Re: REQUEST FOR ADDITIONAL INFORMATION UNIVERSITY OF FLORIDA TRAINING REACTOR DOCKET NO. 50-83

**REQUEST FOR ADDITIONAL INFORMATION  
UNIVERSITY OF FLORIDA TRAINING REACTOR  
DOCKET NO. 50-83**

Responses to  
REQUEST FOR ADDITIONAL INFORMATION  
UNIVERSITY OF FLORIDA TRAINING REACTOR  
DOCKET NO. 50-83

Figure 2 schematic of UFTR secondary coolant system used for determination of heat exchanger inlet/outlet pressures.

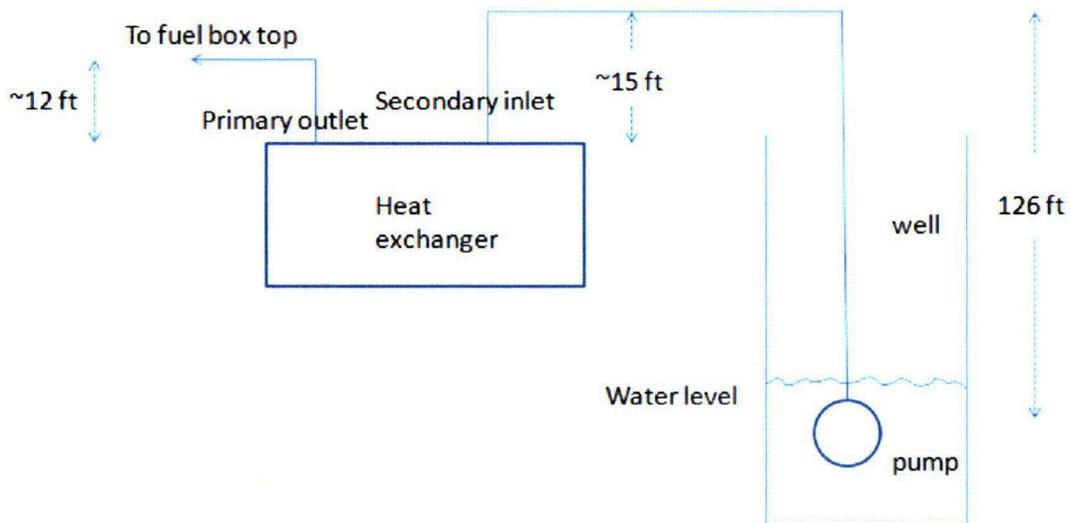
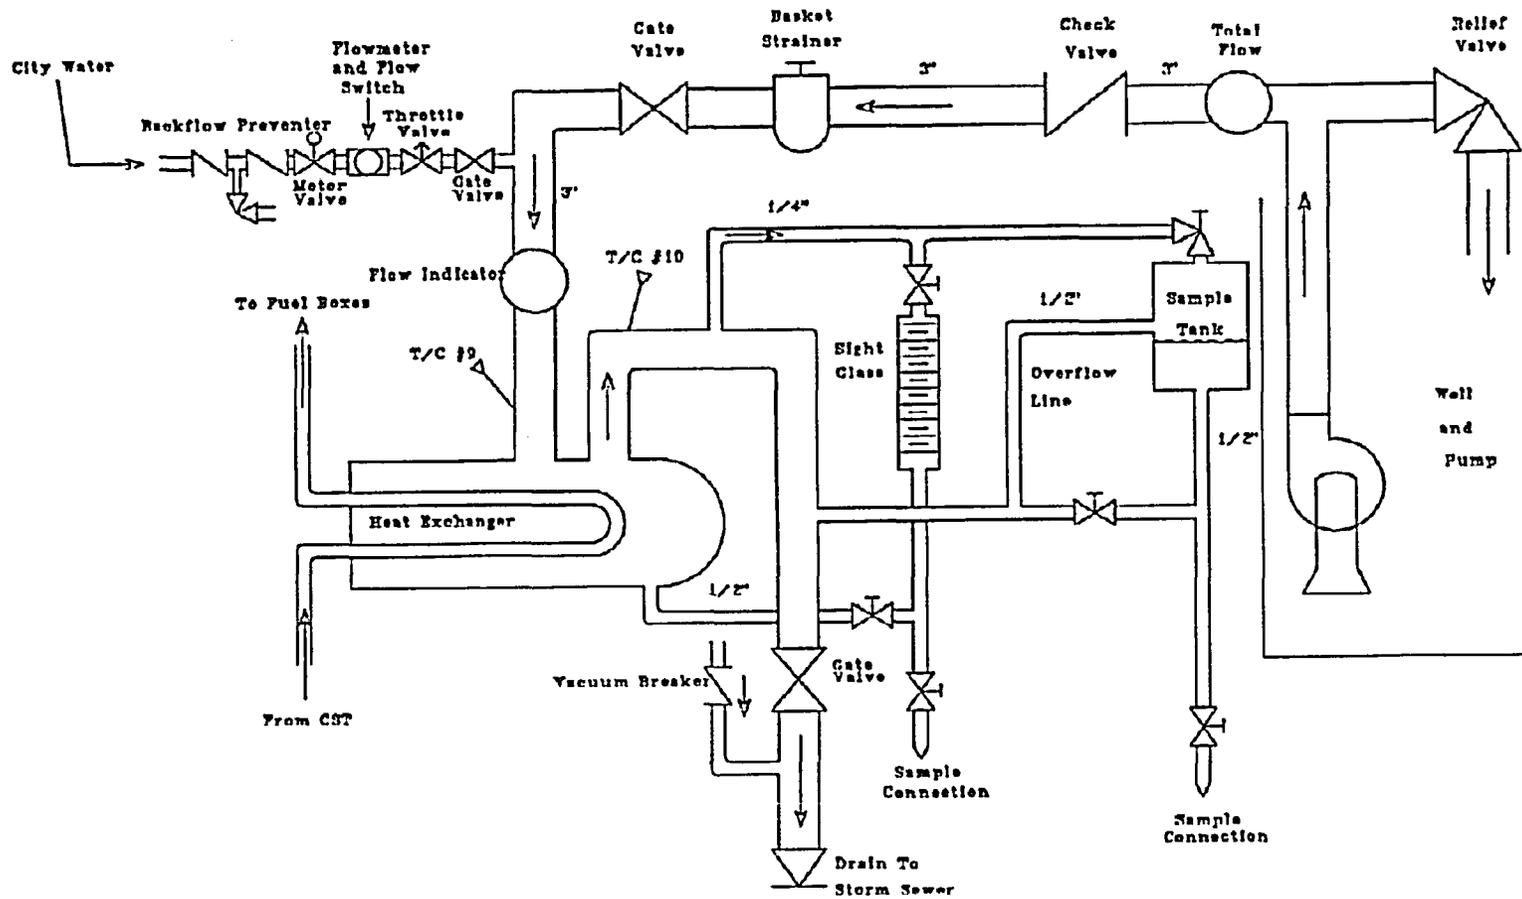
**Question 1:** *Your letter dated April 7, 2008, states that the normal operating pressure for the secondary side is not monitored, but that secondary flow rate is about 4 times higher than the primary flow rate so the dynamic pressure of the secondary system is expected to be higher than the primary system pressure. Therefore, if a significant leak is developed on the primary/secondary boundary, the resistivity of the primary water is expected to change, which is constantly monitored and controlled. The technical specifications (TSs) limits on primary flow rate are greater than 36 gpm or 41 gpm depending on fuel coolant channel spacing tolerance, and the TSs limits on secondary flow rate are greater than 60 gpm when using a well system and 8 gpm when using city water.*

*Is the assumption that a significant leak would be detected in the primary water resistivity valid if the reactor is operating at the TS limit of 36 gpm or 41 gpm primary flow rate (or normal primary flow rate if it is in excess of the allowed TS limit) and 60 gpm or 8 gpm secondary flow rate? In your response, address how the primary and secondary pressures are affected by the flow characteristics in the heat exchanger.*

The heat exchanger shell-side and tube-side inlet/outlet pressures are not monitored in UFTR. However, we can estimate the pressures based on the piping layout and pump characteristics. Figure 5-5 in UFTR SAR shows the schematic of UFR secondary coolant system. The figure is also attached in this document (Appendix A). A simplified version of Figure 5-5 in SAR is used here to estimate the primary outlet and secondary inlet pressures as shown in Figure 2

The well pump, model 150H10 is manufactured by Goulds Pumps, ITT Industry. The specifications of the pump are given in Appendix B. According to the data given in the Appendix, the pump at 10 hp, for 200 gpm, has a dynamic head of 163 ft. In Figure 3,

the height difference between the pump and heat exchanger is ~111 ft (126 ft minus 15 ft). Assuming no significant pressure loss in the pipes, the secondary inlet pressure is about 50 ft (163 ft minus 111 ft) water above the atmosphere pressure. While on the primary side, the height from the heat exchanger to the top of fuel box (where the pressure is atmosphere) is ~12 ft. The primary outlet pressure is about 12 ft water above the atmosphere pressure. Considering 1 psi is equal to 2.306 ft water, then the inlet pressure for the secondary is ~36.4 psi, and the outlet pressure for the primary is ~19.9 psi. Considering the expected pressure drop in the heat exchanger give in Table 2, the secondary outlet pressure is ~34.2 psi, which is ~72% higher than the primary outlet pressure. This difference increases as the secondary flow rate decreases, e.g., at 100 gpm with a dynamic head of 238 ft, the pressure difference is ~251%. This means that there is always a negative pressure which prevents any leak from the primary loop to the secondary loop.

Figure 1 - Comparison of the activity release for different operation time as a function of sodium concentration (100 kW, 1 liter/hr, 60 gpm)

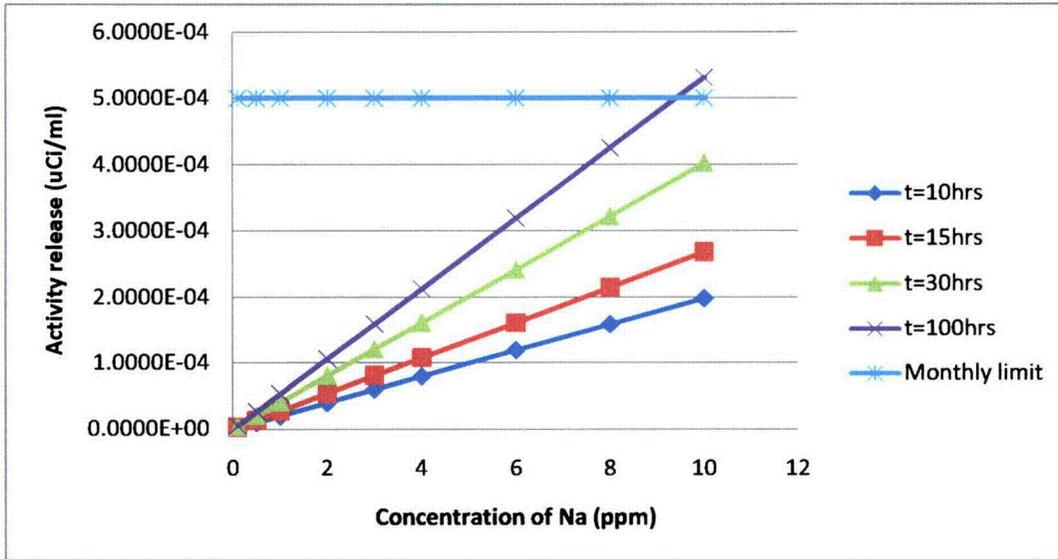
**Question 2a:** *What is the basis for the ‘assumptions of 1 ppm sodium in the primary coolant, activation for 10 hours, and 1 liter/hour leak rate for 1 hour?’*

Here, in order to examine the effect of higher Na concentration and longer operation times, we evaluate the activity release for concentrations in a range of 1-10 ppm for operation hours of 10 to 100 hrs. Figure 1 compares the activity release for different hours of operation as a function of Na concentration in the primary coolant. Note that these calculations are based on 1 liter/hr leakage rate, and 60 gpm secondary flow rate.

Above figure indicates that the activity is less than the monthly limit if sodium concentration is less 9 ppm even at an unrealistic case of 100 hrs of operation. Only, for cases with concentrations between 9 ppm and 10 ppm the concentration exceeds the limit for the 100 hrs operation case. Further, this diagram indicates at a more realistic value of Na concentration of 1 ppm and operation time of 10 hrs, the activity release is less than the limit by a factor of ~25.

Figure 3 - Comparison of the activity release for different sodium concentrations as a function of secondary flow rate for 1 liter/hr leakage (operation time of 10 hrs, 100 kW).

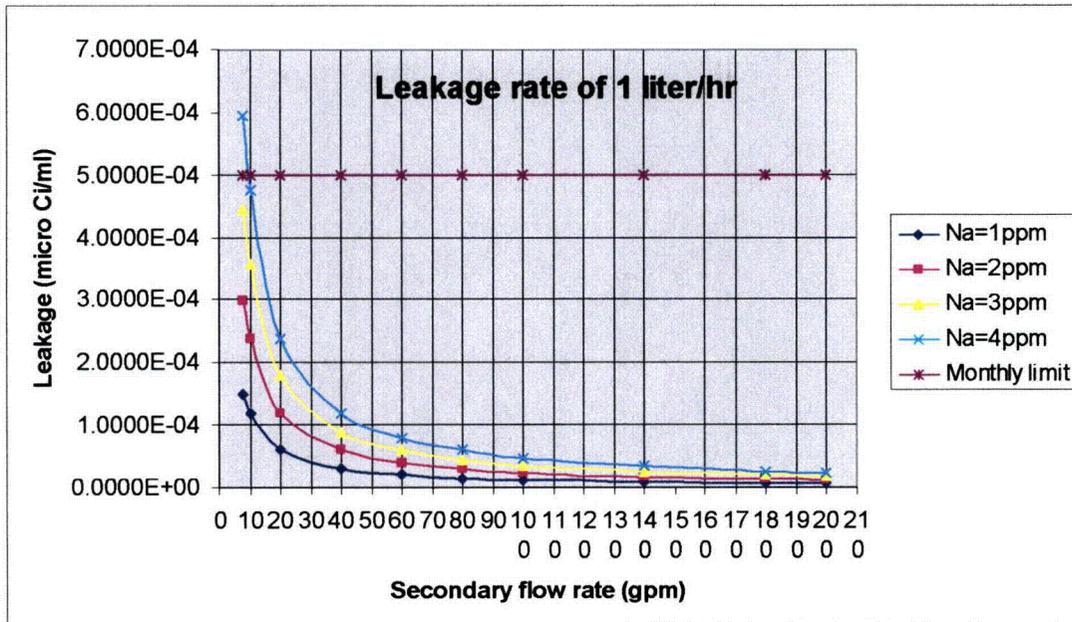
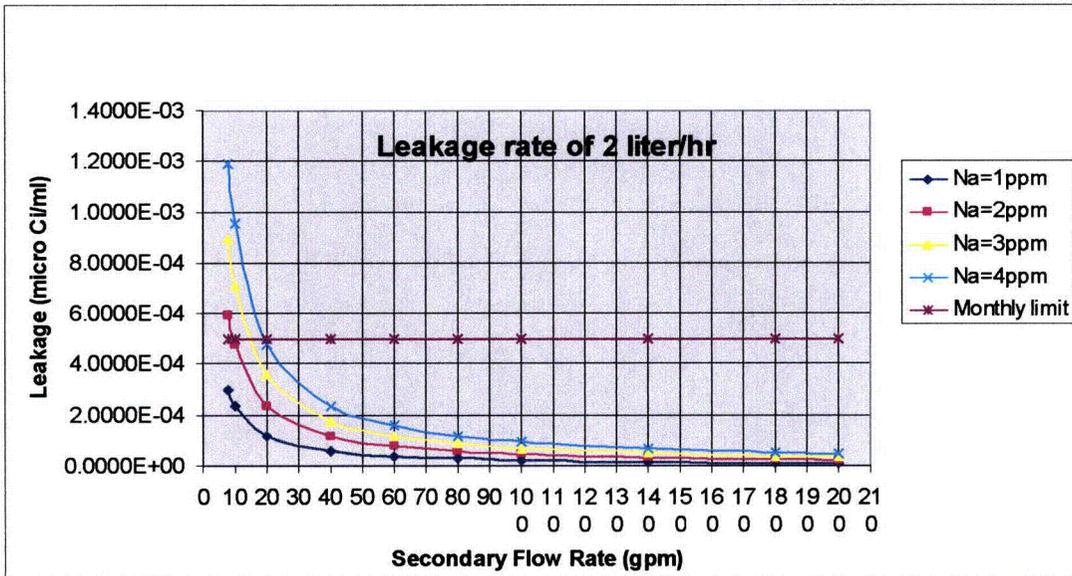
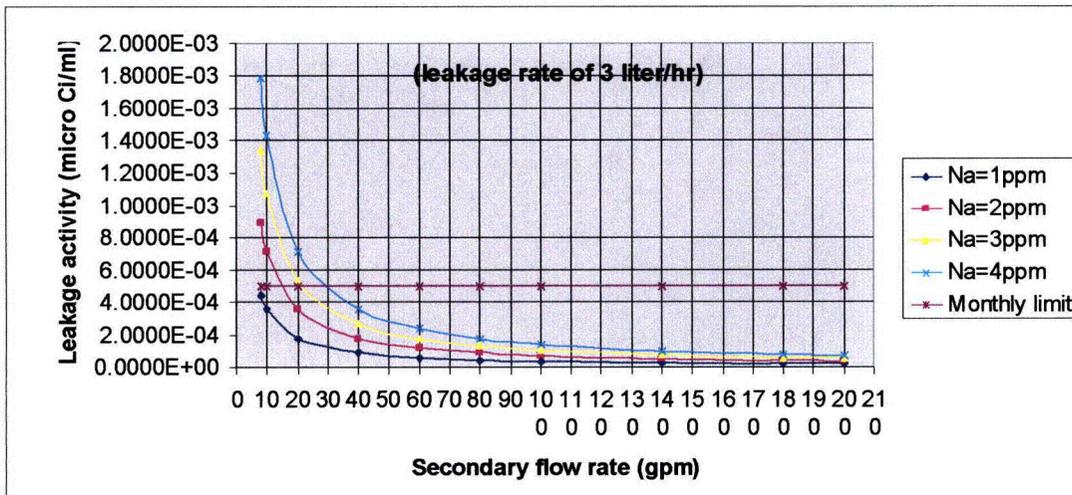
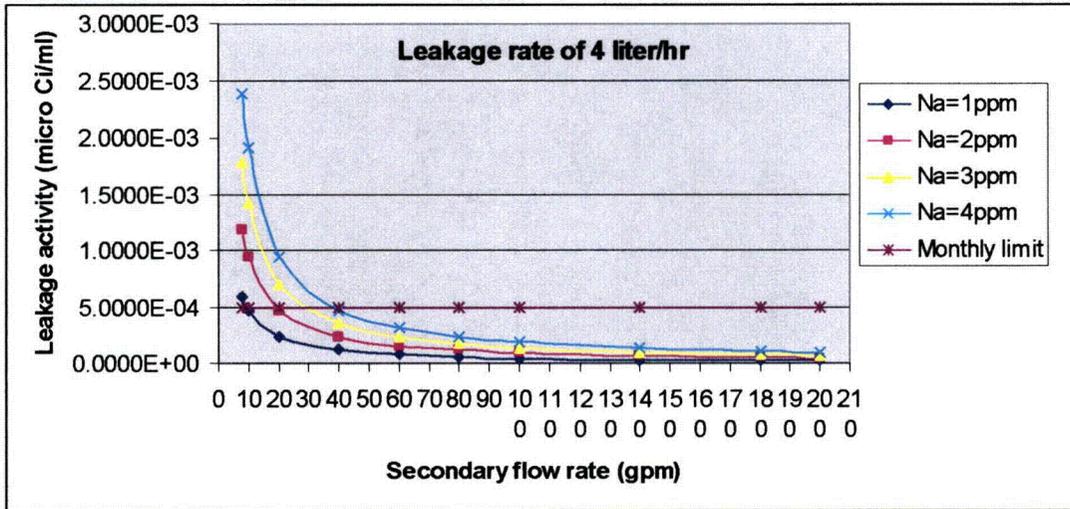
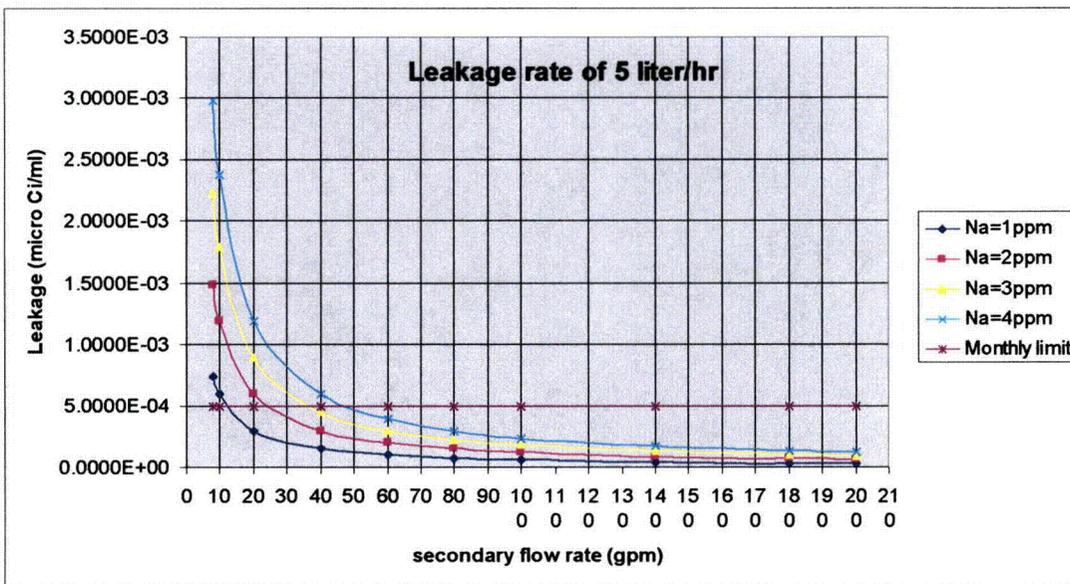
*Question 2c. As discussed previously, the TS limit on secondary flow rate is 60 gpm when using well water and 8 gpm using city water. Therefore, provide an estimated effluent concentration assuming the allowed TS limits for secondary flow.*

Above figure indicates even if the secondary flow is as low as 8 gpm, the leakage activity is less than the limit for Na concentrations of up to 3 ppm. If the secondary flow rate between 100 gpm to 200 gpm, where the latter is the nominal value, for a more realistic Na concentration of 1 ppm, the leakage activity varies in the range of  $1.2 \times 10^{-5}$  to  $6 \times 10^{-5}$  which is significantly smaller than the limit by a factor of ~40 to ~100.

Figs. 4 to 7 show the leakage activity as a function of secondary flow rate for different Na concentrations for leakage rates of 2, 3, 4, and 5 liter/hr, respectively.

Above figure shows that as long as secondary flow rate is more than 60 gpm even for 5 liter/hr leakage rate, for a realistic Na concentration of 1 ppm, and 10 hrs of operation time at 100 kW, leakage activity is significantly less than the limit by a factor of ~5.

In conclusion, above analysis demonstrates that considering highly conservative parameters including operation time of 10 hrs, total flux level of  $2 \times 10^{12}$ , leakage rate of 5 liter/hr, power of 100 kW, and Na concentration of 1 ppm, leakage activity will remain significantly below (by a factor of 5) the monthly limit if the secondary flow rate is above 60 gpm.

Since the city water is not meant to be used for normal operation, and reactor does not need cooling in case of loss of coolant, we intend to modify the Technical Specification by removing the use of city water and increasing the secondary flow trip setpoint to 100 gpm. For this situation even for the leakage rate of 5 liter/hr, the activity leakage is less than the limit by a factor of 10.
